ADDENDUM NO: 1

PROJECT: **SITE IMPROVEMENTS AT FRANKLIN CENTRAL JUNIOR HIGH**

CONTEXT PROJECT NO: 22-1613 DATE: 2/13/2024 BY: Fred Prazeau

0' 30' 60'

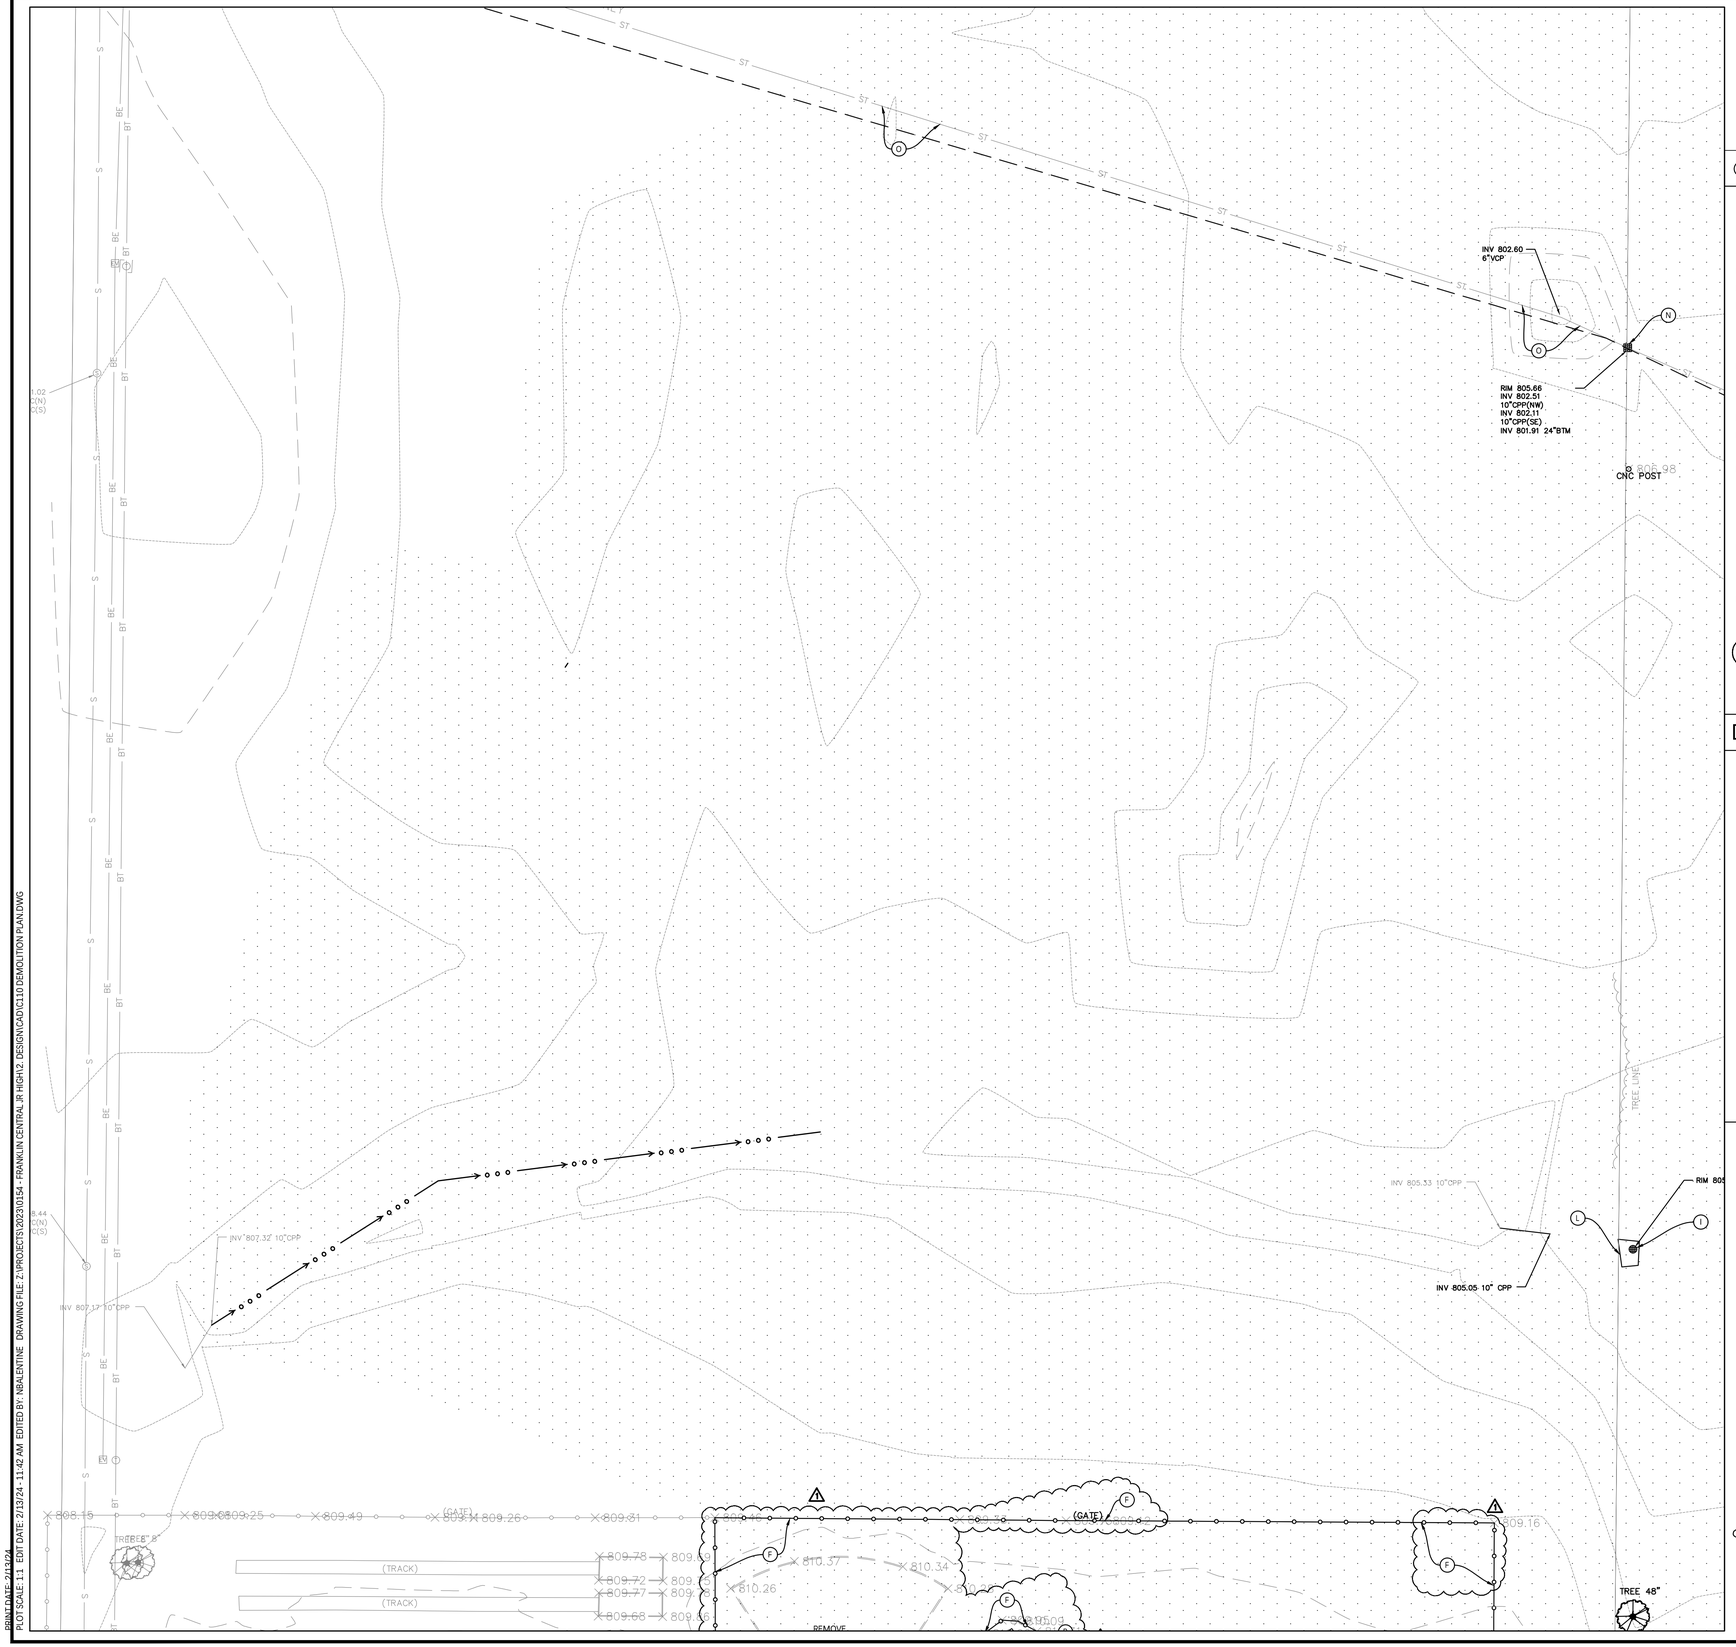
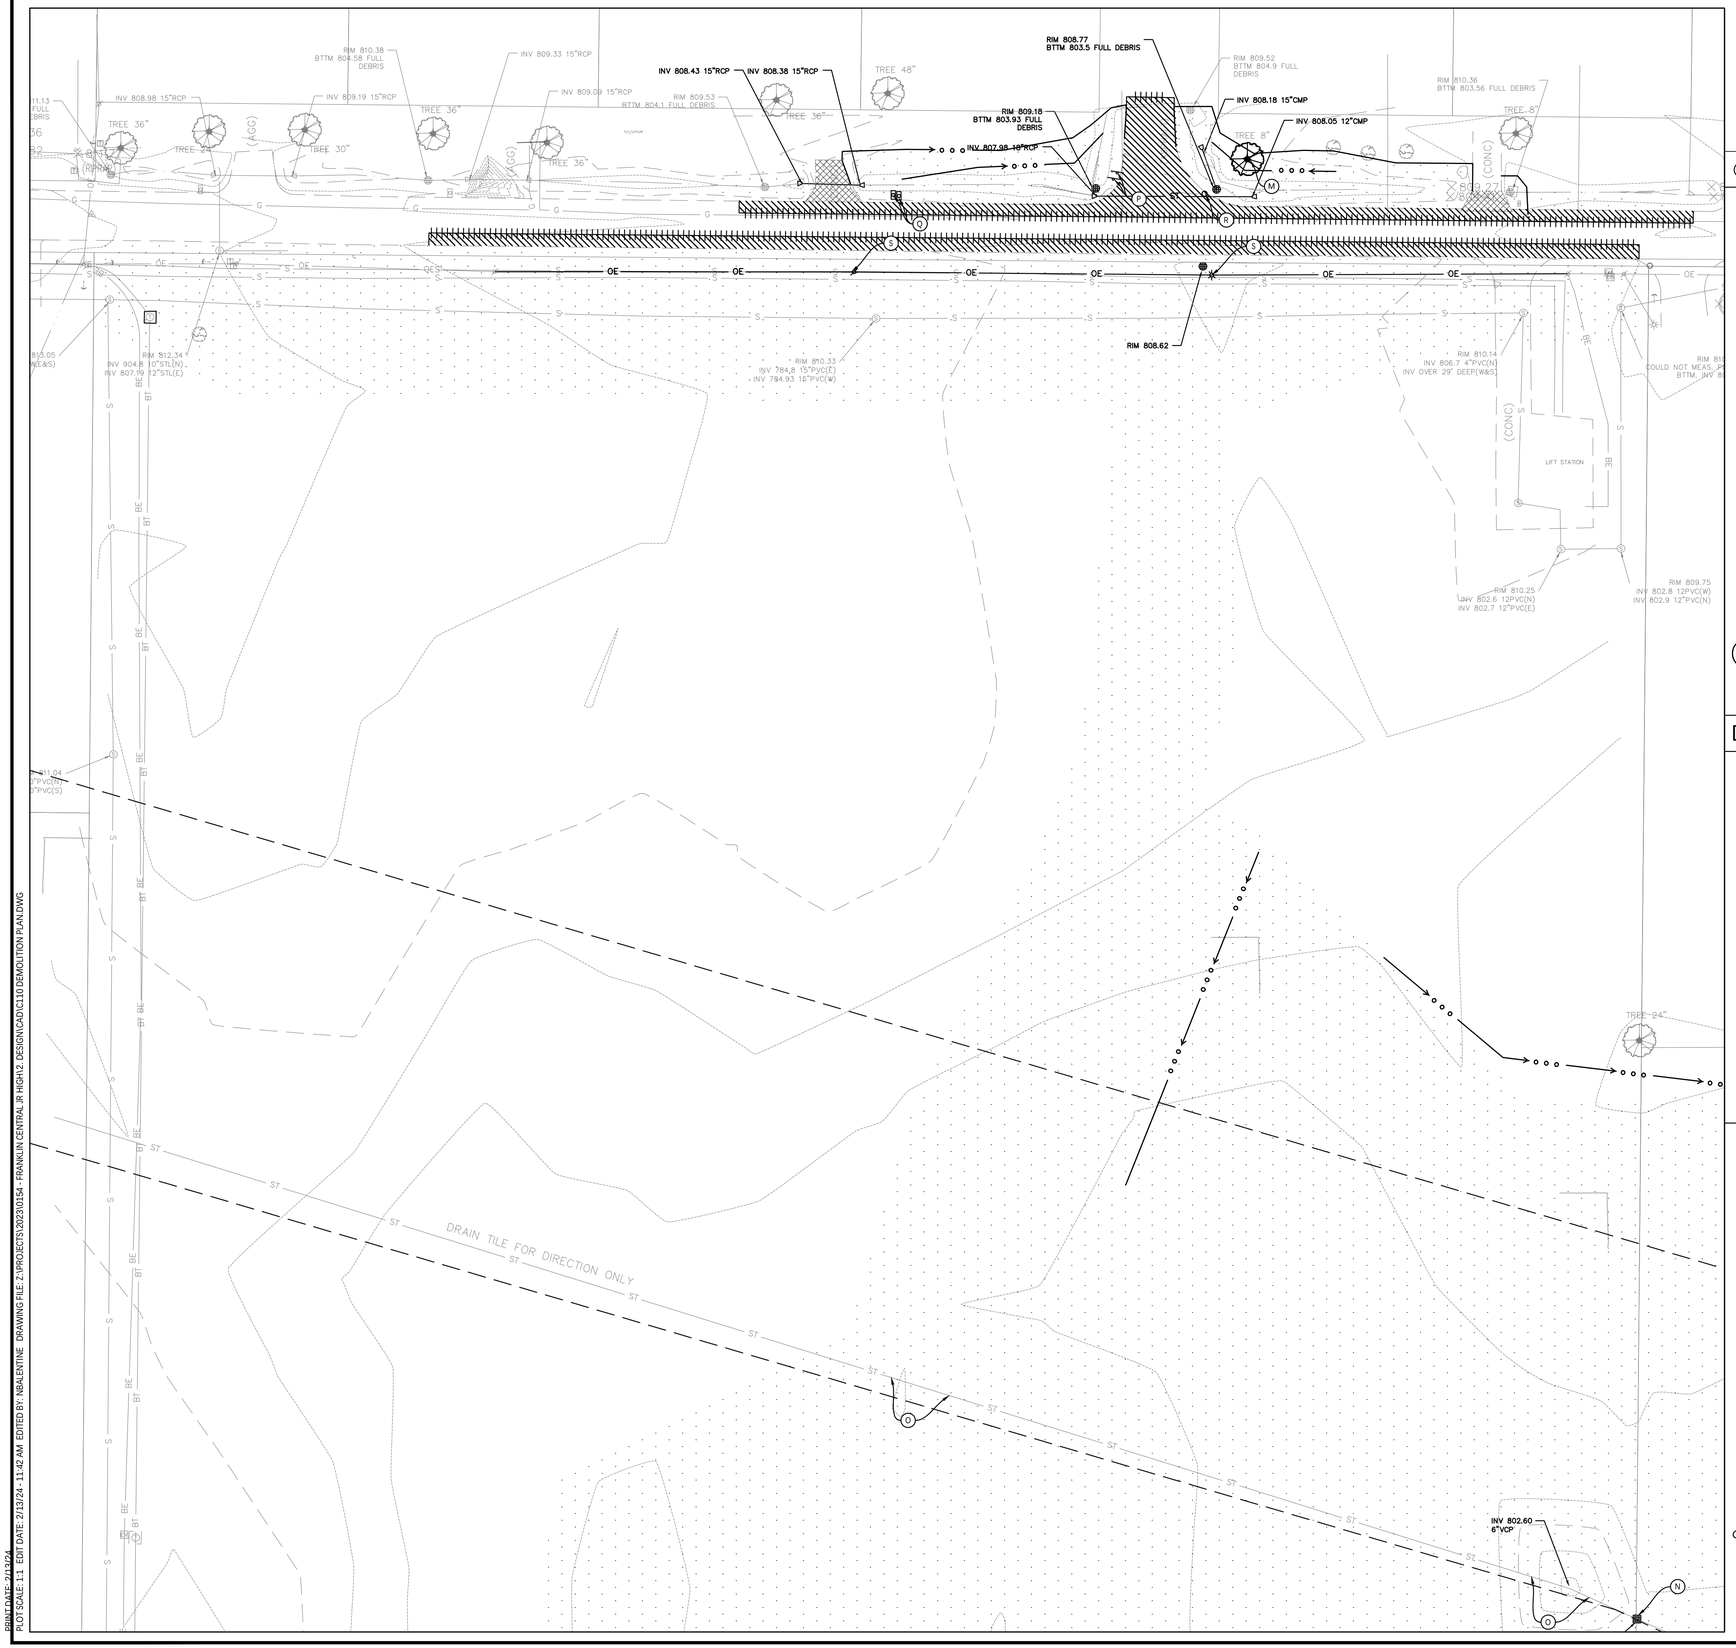
1. C110-Series Demolition Plans reissued to address City comments, including clarification on fence and gate removal, throwing area removal, and relocation of sprinkler vault.
